Brooks County High School Field House HVAC upgrades.

ADDENDUM NO. 1

ADDENDUM NO. 1

DATE: July 02, 2025
Project: Falfurrias HS Fieldhouse HVAC Upgrades
Project #: 25v50
To: David Monreal, GMS

ME2.3

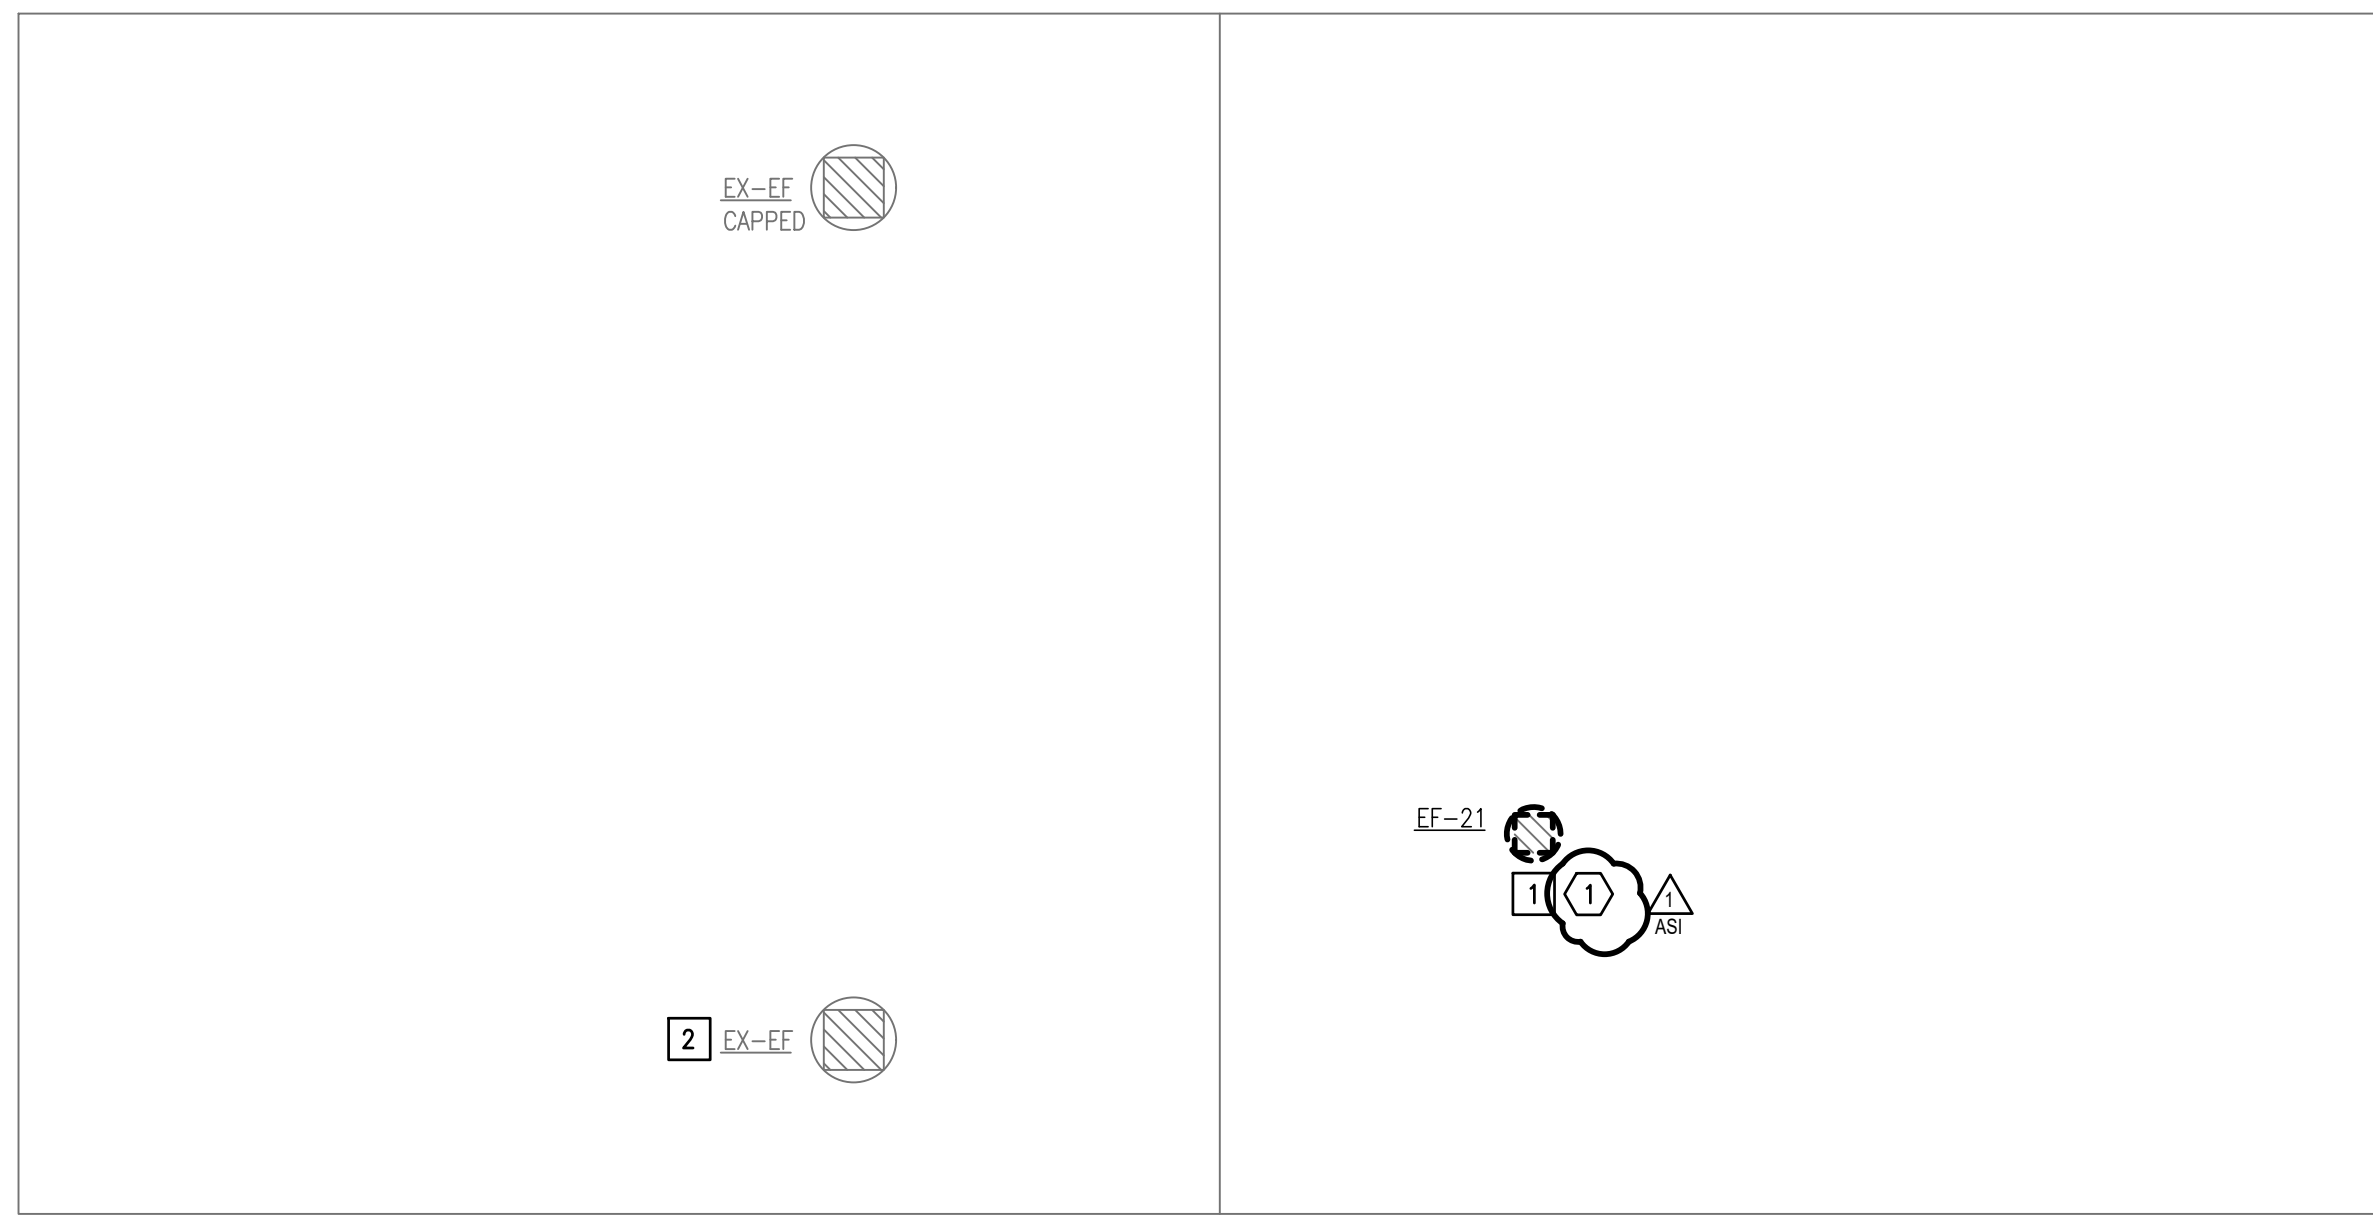
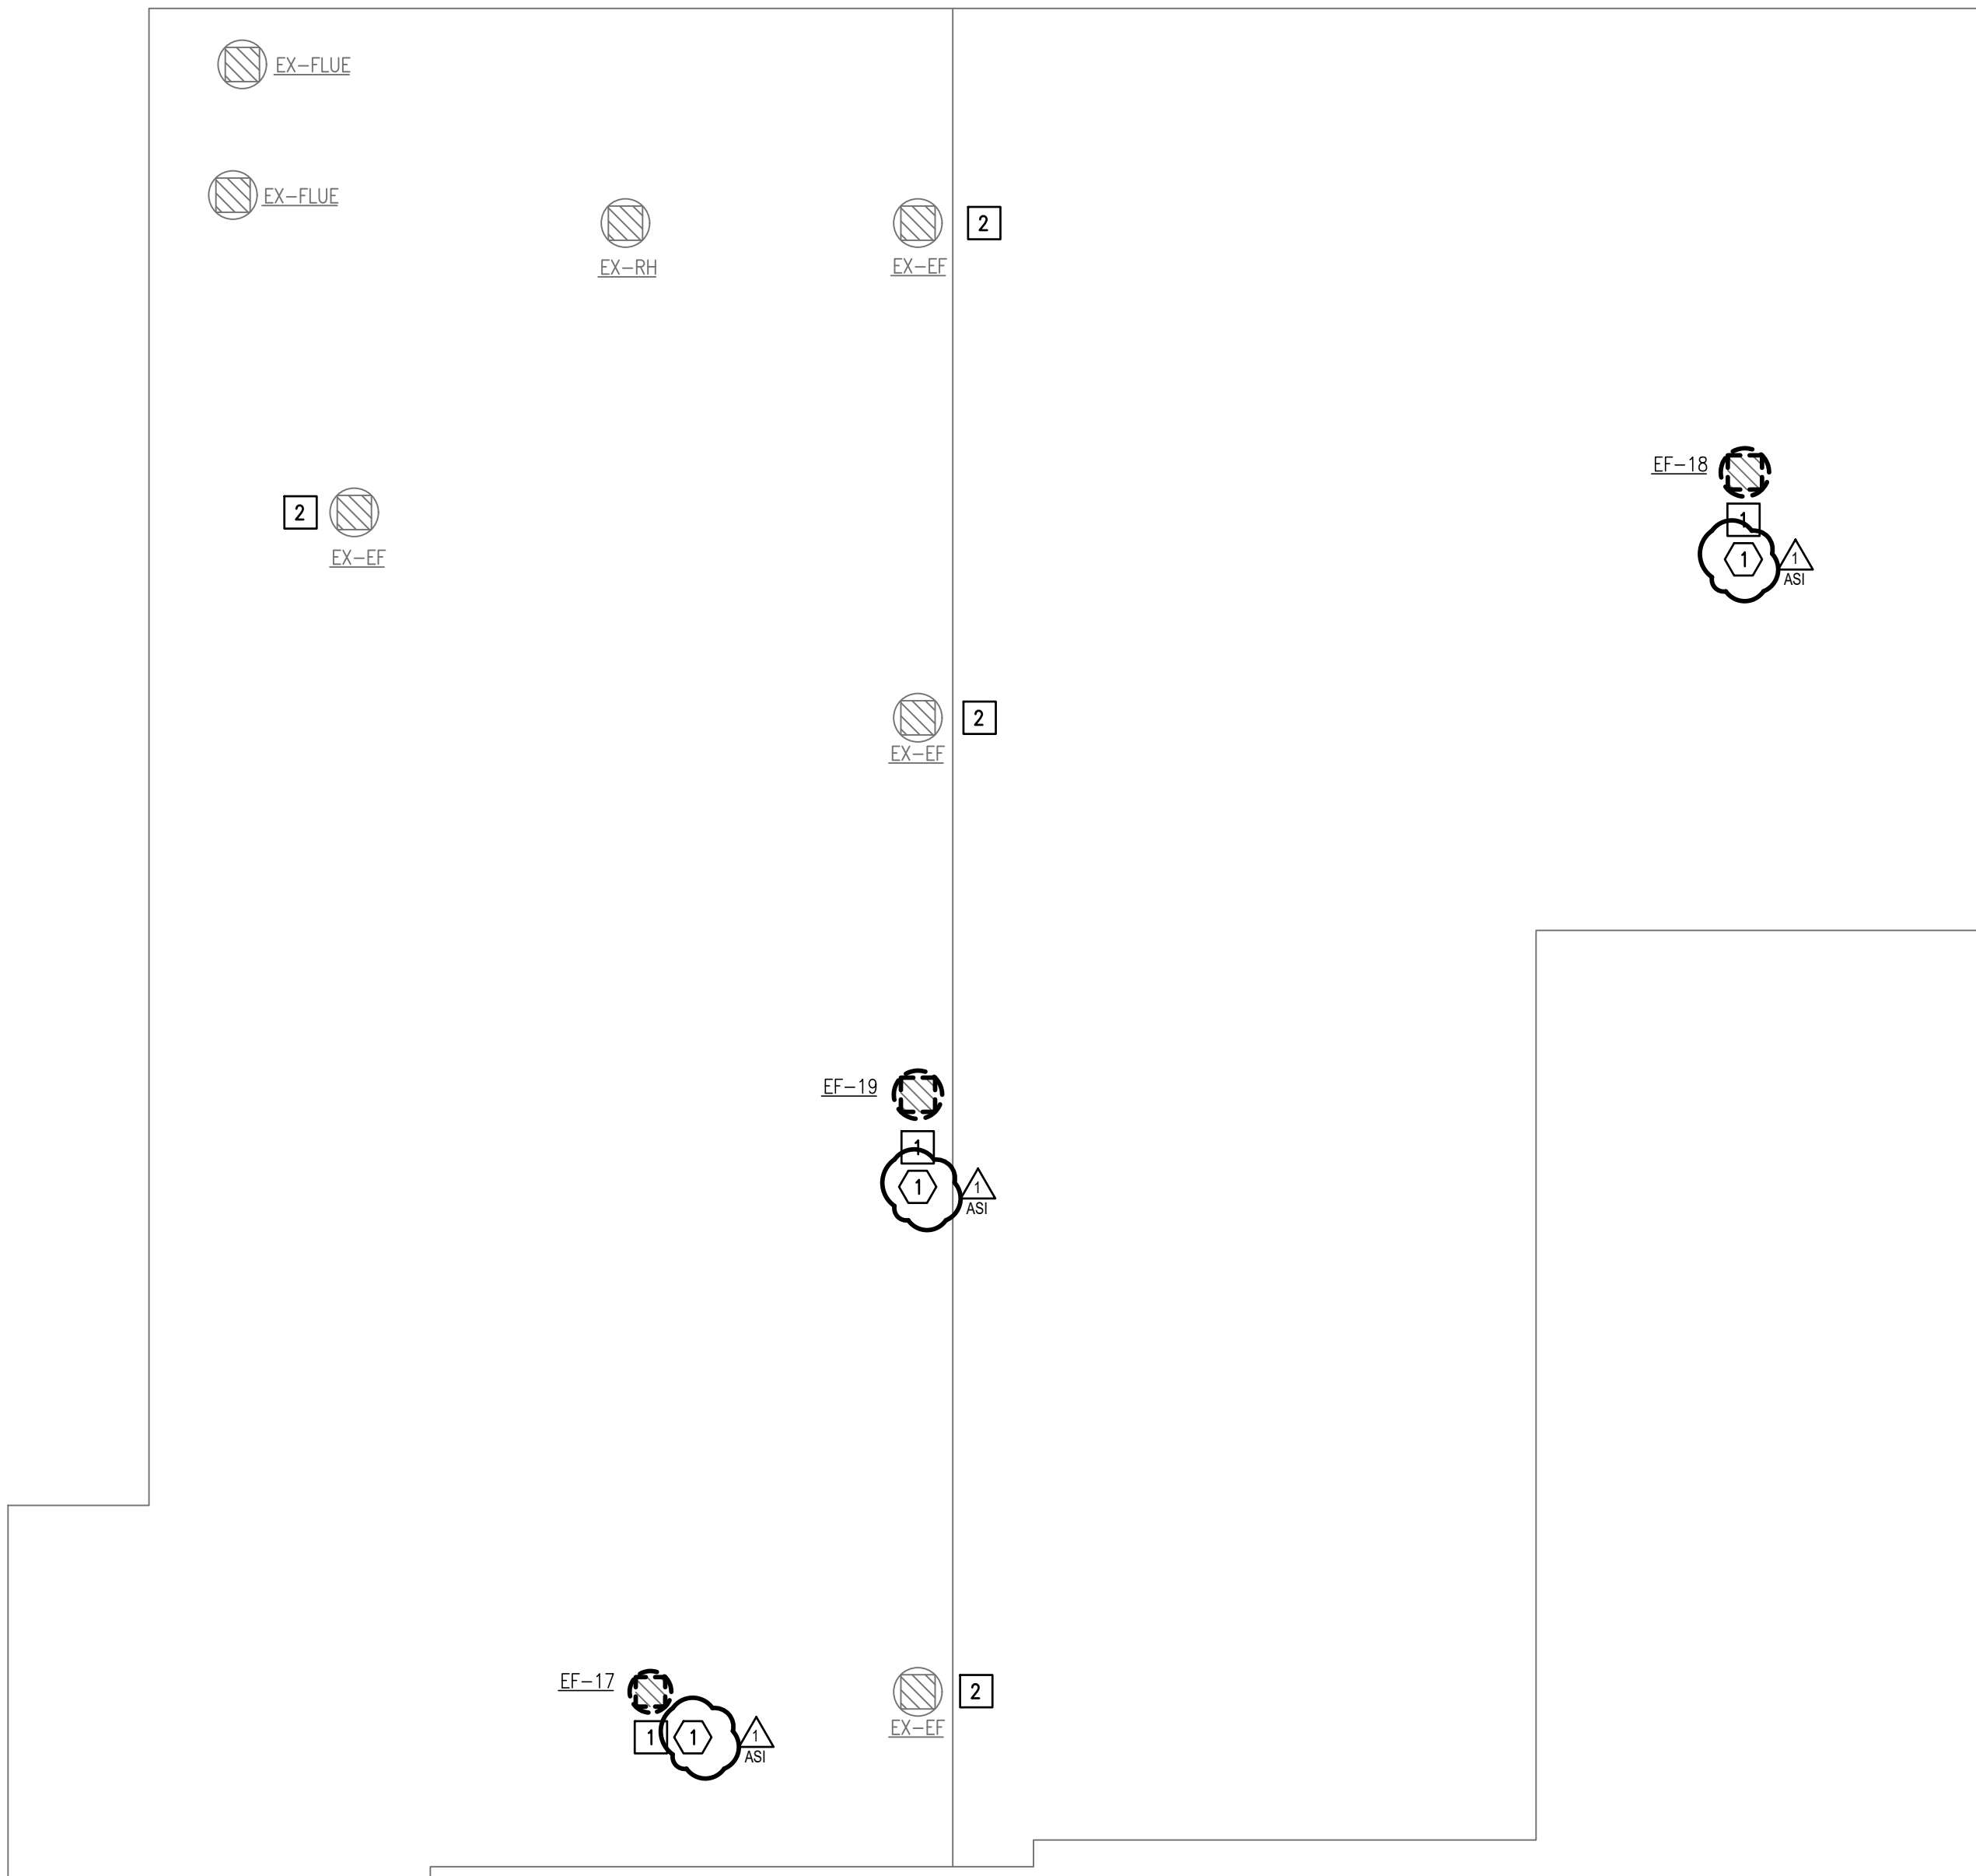
1. Sheet ME1.0:
 - a. Revised Mechanical and Electrical General Notes. See attached data sheet.
2. Sheet ME2.1:
 - a. Revised Building M and Building L Mechanical and Electrical demolition plan. See attached sheet.
3. Sheet ME2.2:
 - a. Revised Building M and Building L Mechanical and Electrical demolition plan. See attached sheet.
4. Sheet ME2.3:
 - a. Revised Building M and Building L Mechanical and Electrical demolition roof plan. See attached sheet.
